Project	IEEE 802.16 Broadband Wireless Access Working Group < http://ieee802.org/16 >	
Title	Contribution in Support of Comment Related to the Scope of 802.16i	
Date Submitted	2007-01-18	
Source(s)	Erik Colban Nextwave Broadband Inc 12670 High Bluff Dr. San Diego, CA 92130	Voice: +1 858 480 3240 ecolban@nextwave.com
Re:	This contribution is in response to the call for contributions in 802.16i-06/012.	
Abstract	This contribution addresses the requirement in the document scope (and project PAR) that requires "protocol neutral methodologies" and multiple solution sets. It proposes a new informative annex where examples are given showing how the ASN1 based MIBs may be a basis for management using other paradigms than SNMP, e.g., Web Services or CORBA based management.	
Purpose	Discuss proposed approach and agree.	
Notice	This document has been prepared to assist IEEE 802.16. It is offered as a basis for discussion and is not binding on the contributing individual(s) or organization(s). The material in this document is subject to change in form and content after further study. The contributor(s) reserve(s) the right to add, amend or withdraw material contained herein.

Contribution in S

Figure 2 – Possible distribution of the NCMS

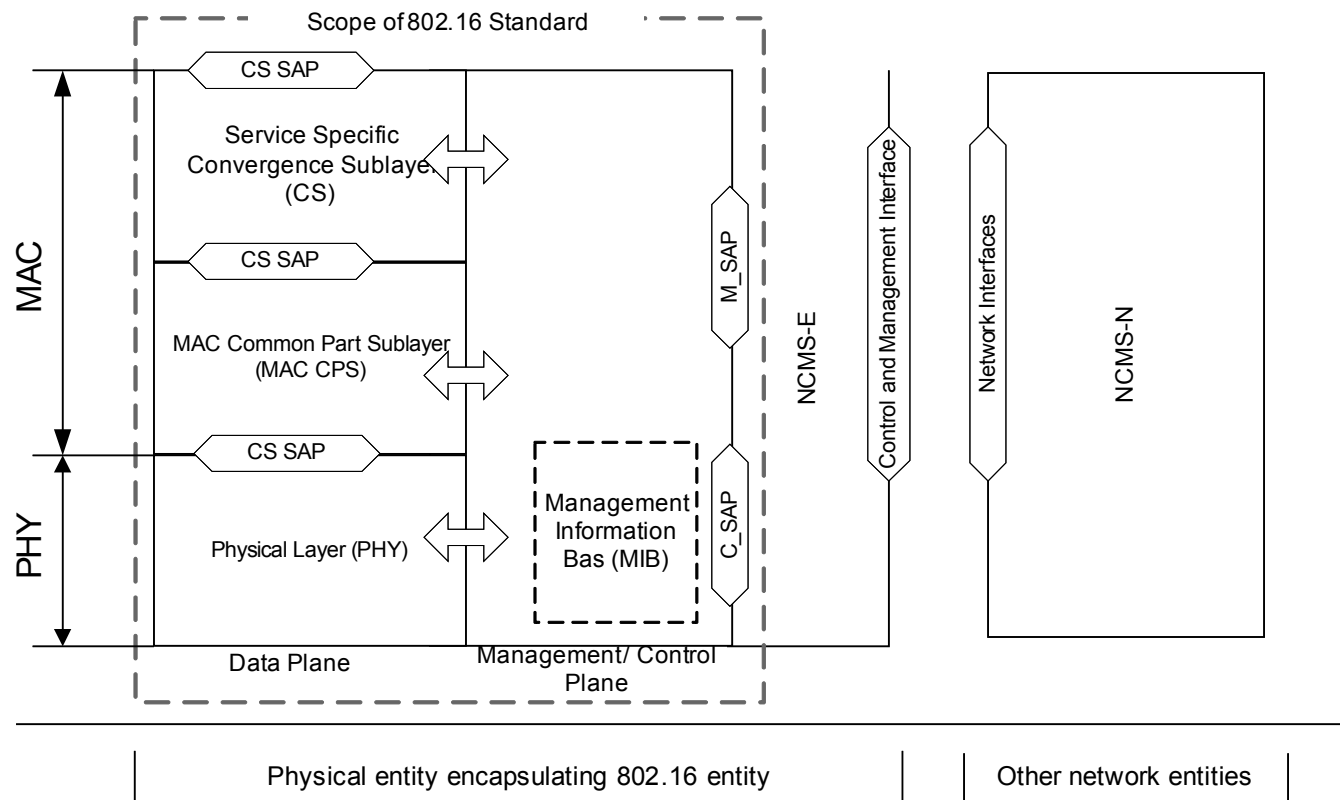
The Network Control and Management System (NCMS) is not part of the 802.16 standards and is treated as a “black box”. It may be distributed with parts residing on different nodes in a network. Part of the NCMS may be physically collocated with the 802.16 entity. In this Annex, this part is referred to as NCMS-E. The remaining part of the NCMS may be physically distributed across one or more other network entities. This part of the NCMS is referred to as NCMS-N. Figure 2 shows the partition of the NCMS into NCMS-E and NCMS-N.
